FILE NUMBER: Z223-348(JA) **DATE FILED:** September 29, 2023

REQUEST: An application for an amendment to Planned Development District No. 1050.

SUMMARY: The applicant proposes to construct an addition to an existing public school. [*Rosemont Upper School*]

Proposed Amended Development Plan

Z100

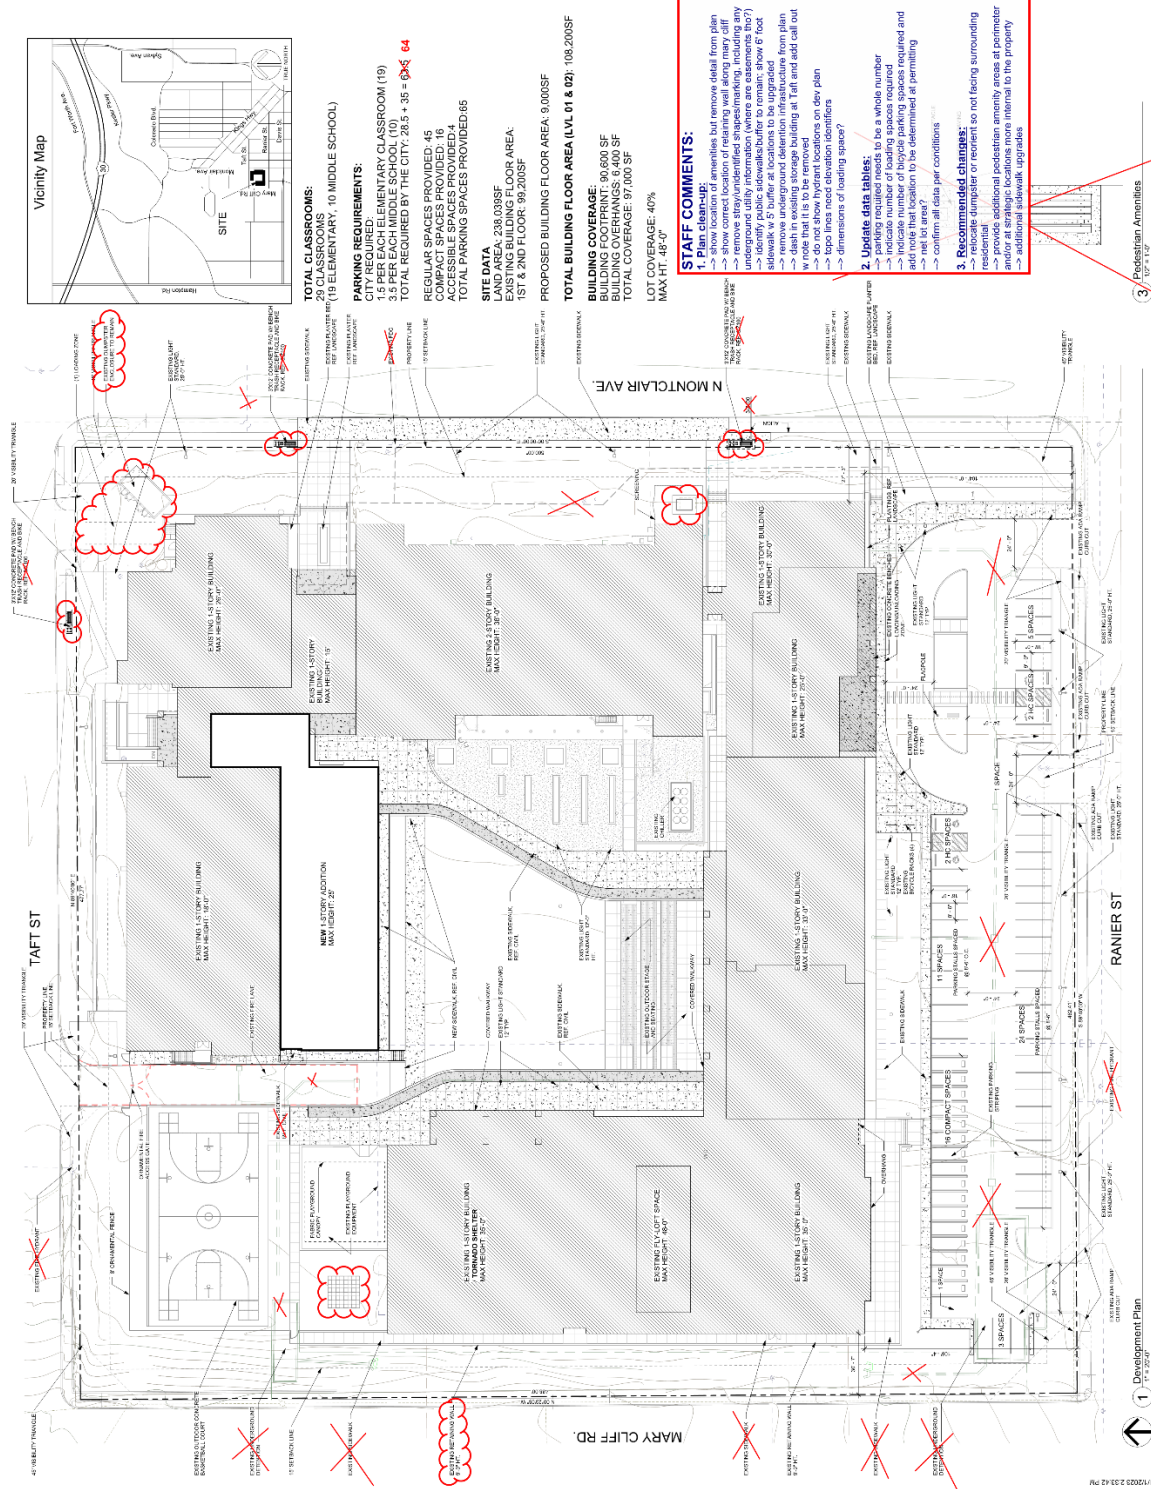
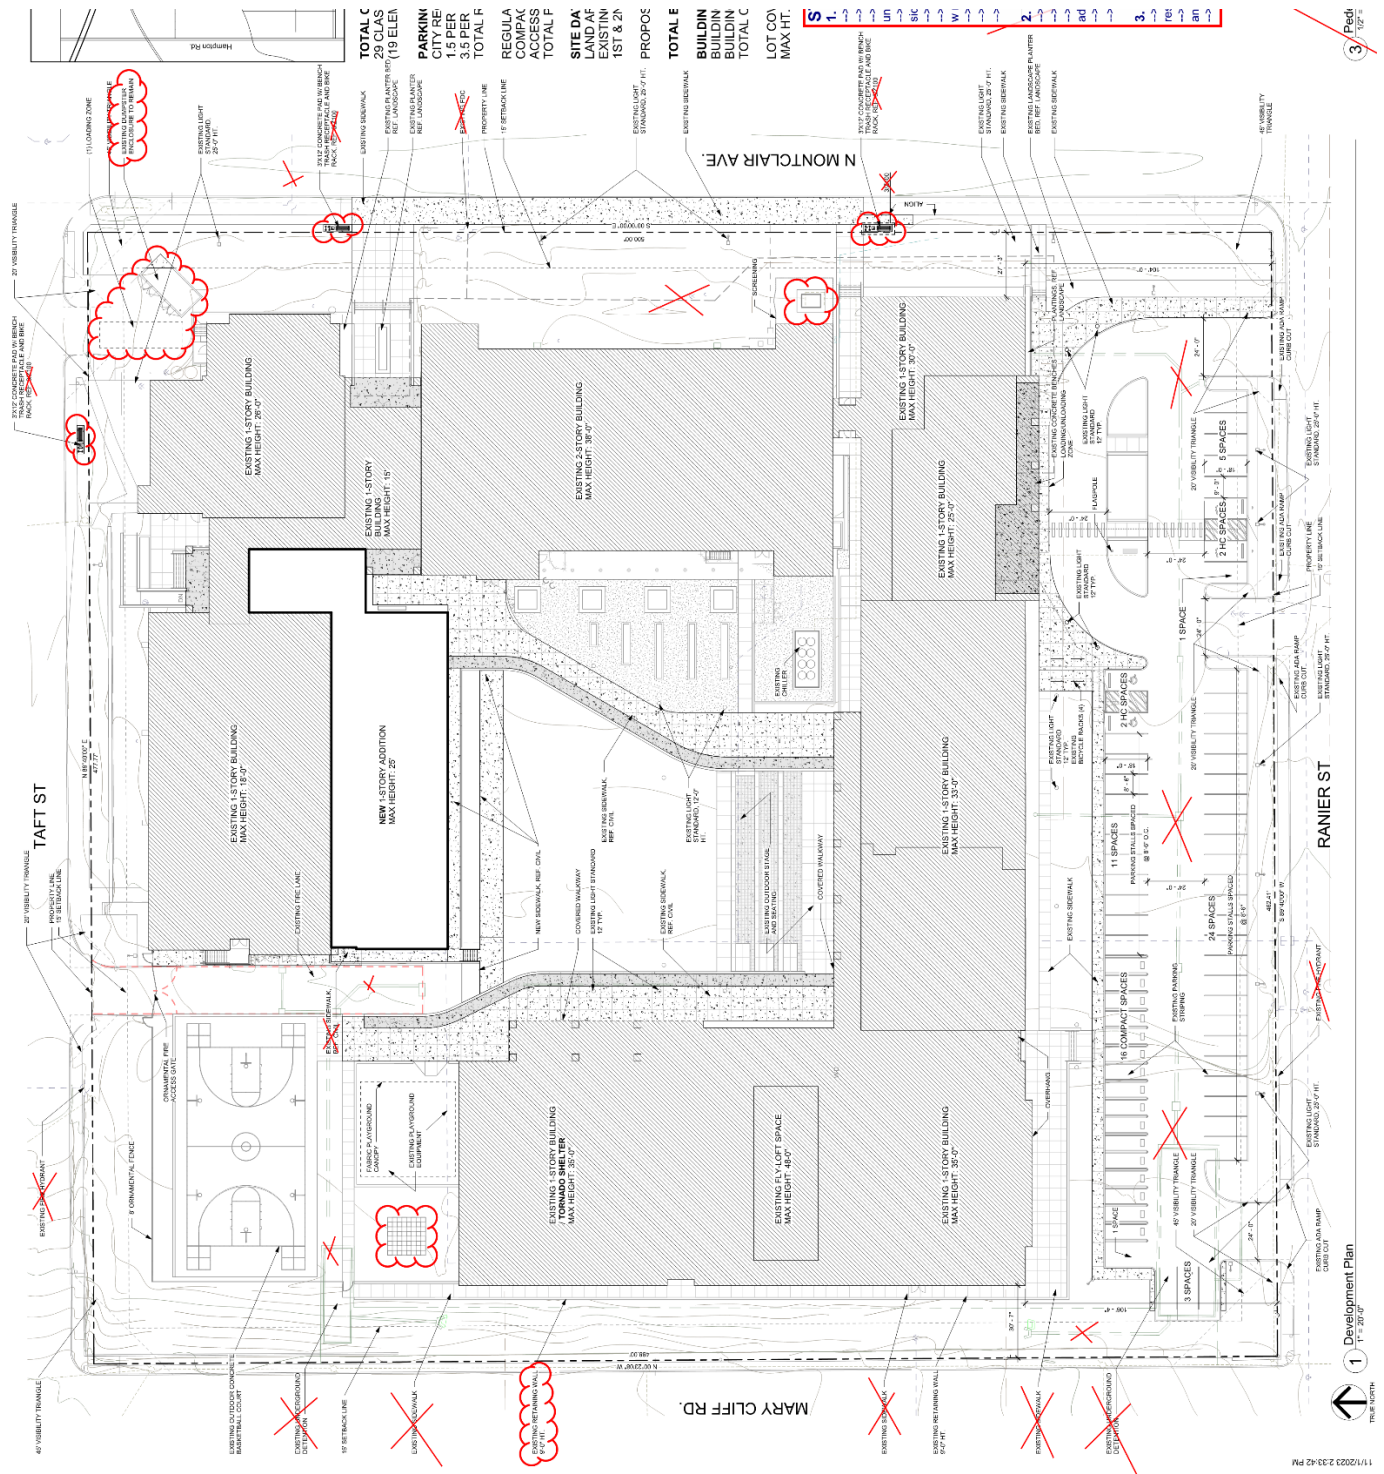
STAFF COMMENTS:

1. Plan clean-up:

- > show location of amenities but remove detail from plan
- > remove any unneeded site details
- > remove site/identified spaces/markings, including any underground utility information (where are easements tho?)
- > identify public sidewalk/bike to remain, show 6' foot
- > remove underground detention infrastructure from plan
- > dash in existing storage building at Tail and add call out
- > show 80' show hydrant locations on dev plan
- > top lines need elevation identifiers
- > dimensions of loading spaces?

2. Update data tables:

- > parking required needs to be a whole number
- > indicate number of loading spaces required
- > indicate number of compact spaces required
- > add table that location to be determined at permitting
- > not for area?
- > confirm all data per conditions

3. Recommended changes:

- > relocate dumpster or recipient so not facing surrounding residential
- > additional pedestrian amenity access of perimeter and/or at strategic locations more internal to the property
- > additional sidewalk upgrades

Proposed Amended Landscape Plan (pg. 1)

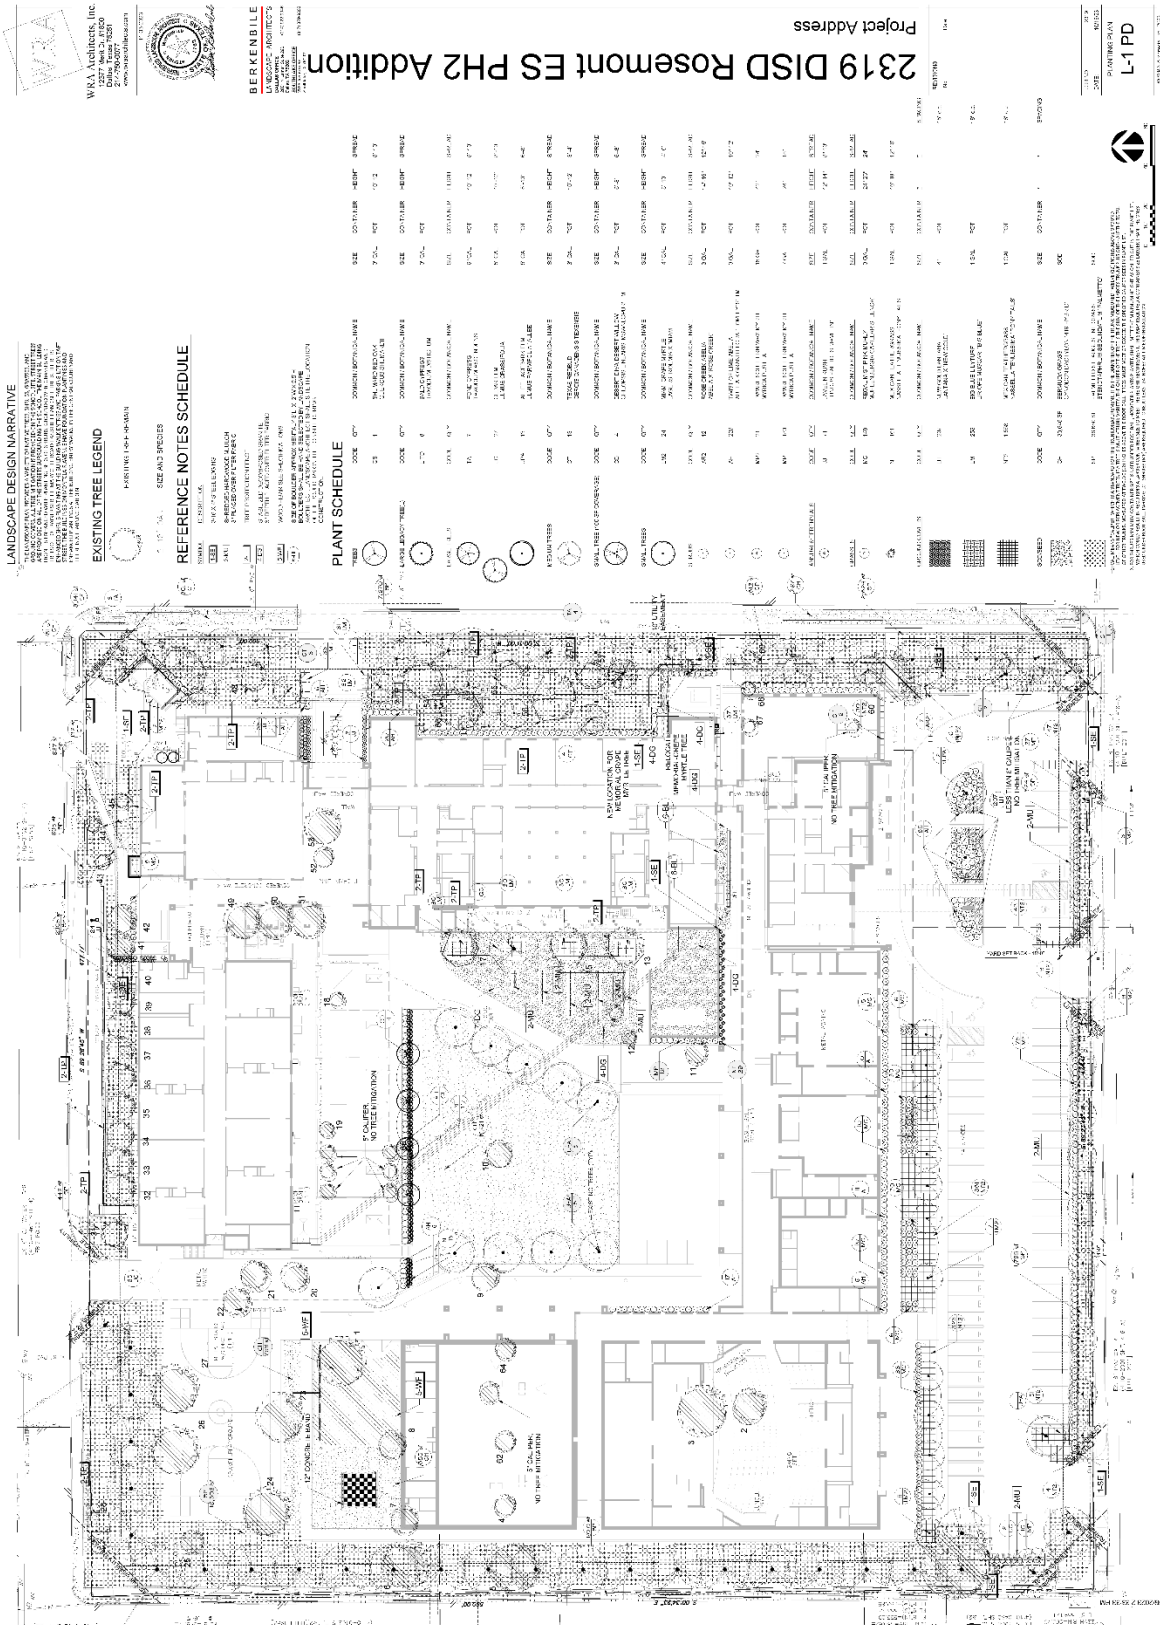
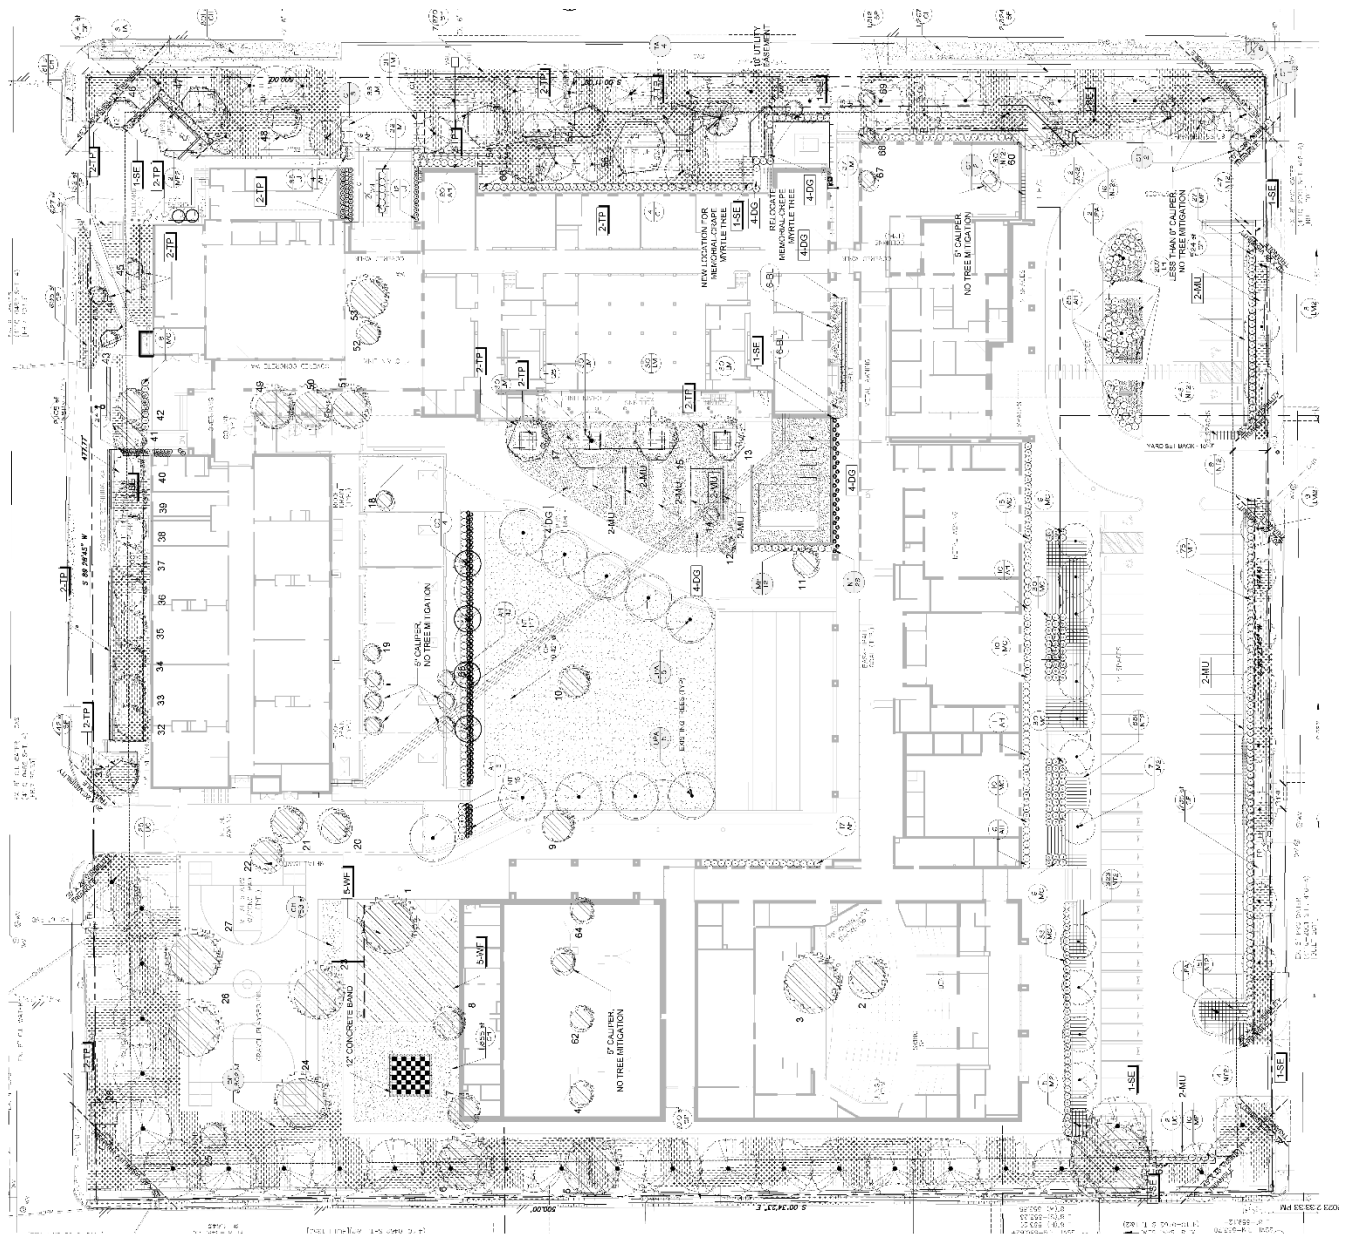
The city arborist has reviewed the proposed amended landscape plan and recommends that page two be eliminated from the exhibit. Page two has tree mitigation tables that should only be applied with the building permit review. Additionally, the proposed tree mitigation standards vary appreciably from Article X tree conservation regulations, and the city arborist does not recommend the proposed deviation. Page two also has “legacy tree” information that is not applicable to a property over five acres [ref. Sec. 51A-10.135(b)]:

The city arborist supports the current zoning request, subject to the revisions noted above. Additionally, the landscape plan needs to be revised for consistency with the development plan as applicable.
